Decommissioning What's At Stake?

Lynnette Hendricks, NEI

11/8/99

Figure 5-1
COMPARISON OF POINT ESTIMATES

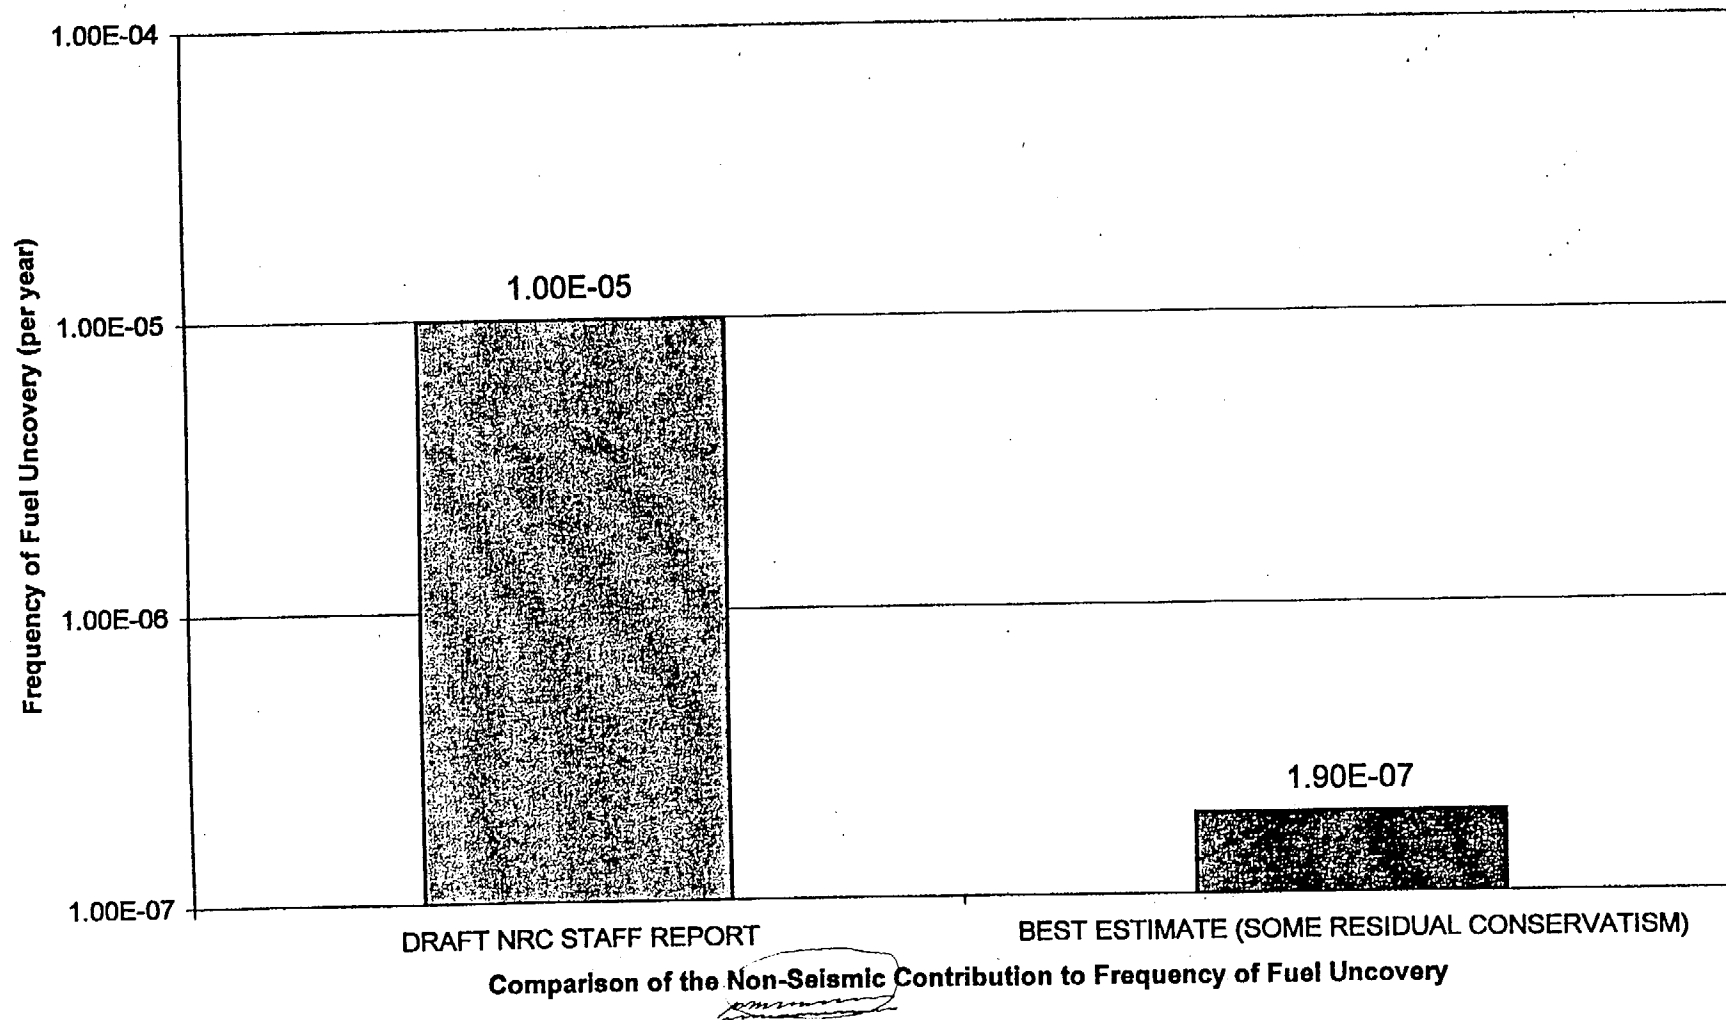
Fuel Uncovery Endpoint

- Not related to public risk
- Postulated runaway oxidation correlates with risk to public
- Realistic heatup and endpoint adds 3 days to recovery time! (8 days Vs. 5)

- Credit industry commitments
- Revise study to:
 - Use best estimates
 - Remove conservatisms
- Truncate sequences beyond 2 days
- Requantify Model
